Access Compliance Report

(Curb Ramps)

Intersection ID: 28369	Main Street: TONAWANDA_DR	Cross Street: BURNSIDE_LN	Location: S
ADA ID: 581F5B26B091	Ramp Type: BlendTrans1	Initial Pass/Fail: Pass	Overall Compliance: No
Severity Score: 0.25			
Codes/Mitigation Info/Possible Solution		Field Measurements/Component Compliance

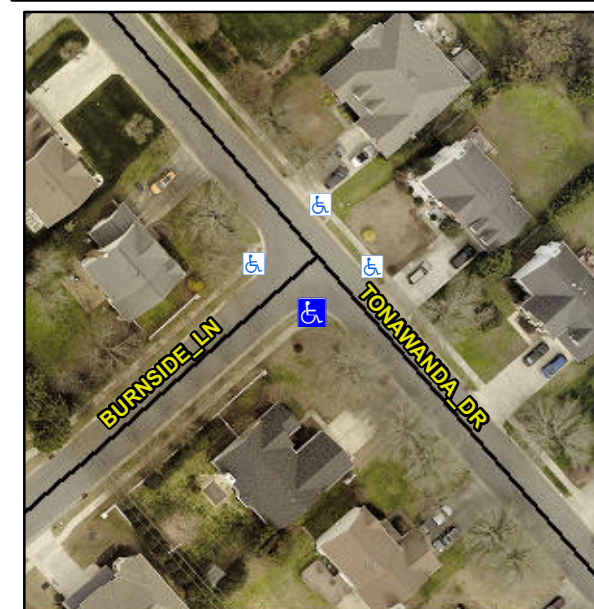
NO LT SW

Not Found, R304.5.3, R304.2.1

Compliance	Description	Data	Compliance	Description	Data
N/A	Ramp Length (in)	48.0	Yes	BlendTrans Slope (%)	4.3
Yes	Ramp Width (in)	48.0	No	BlendTrans XSlope (%)	2.4
N/A	Flare Type LT	Sloped	N/A	Flare Type RT	Sloped
N/A	Flare Slope LT (%)	3.6	N/A	Flare Slope RT (%)	1.9
N/A	Flare Traversable LT?	No	N/A	Flare Traversable RT?	No
No	Landing Length (in)	47.0	Yes	DWS Provided?	Yes
Yes	Landing Width (in)	48.0	Yes	DWS Contrast?	Yes
Yes	Landing Slope (%)	1.5	Yes	DWS Length (in)	24.0
Yes	Landing X Slope (%)	1.5	Yes	DWS Full Width?	Yes
N/A	Landing Curb? (Y/N)	No	Yes	DWS Offset (in)	2.0
N/A	Shared Landing?	No			
Yes	Gutter Ponding?	No	Yes	Gutter Slope (%)	2.2
Yes	Gutter Lip Ht (in)	0.0	Yes	Gutter X Slope (%)	2.0
N/A	Painted X Walk1?	No	N/A	Painted X Walk2?	No
	X Walk 1 Direction	To NE		X Walk 2 Direction	To NW
	X Walk 1 Width (in)	N/A		X Walk 2 Width (in)	N/A
	X Walk 1 Slope (%)	2.5		X Walk 2 Slope (%)	3.8
	X Walk 1 X Slope (%)	1.7		X Walk 2 X Slope (%)	1.2

N/A	Ramp inside XWalk1?	N/A	N/A	Ramp inside XWalk2?	N/A
	Road Slope (%)	0.1		Clear Space?	Yes
	Road X Slope (%)	2.9	N/A	Clear Space to XWalk (in)	N/A
Yes	Any Obstructions?	No	Yes	Storm Grate/Utility Hazard?	No
	Obstruction Type			Storm Grate/Utility Type	
		N/A			N/A
			Yes	Surface Condition? (G/P)	Good
			No	Curb Slope (%)	8.9

Remove & Replace Curb Ramp With Two New Directional Ramps or Equivalent.
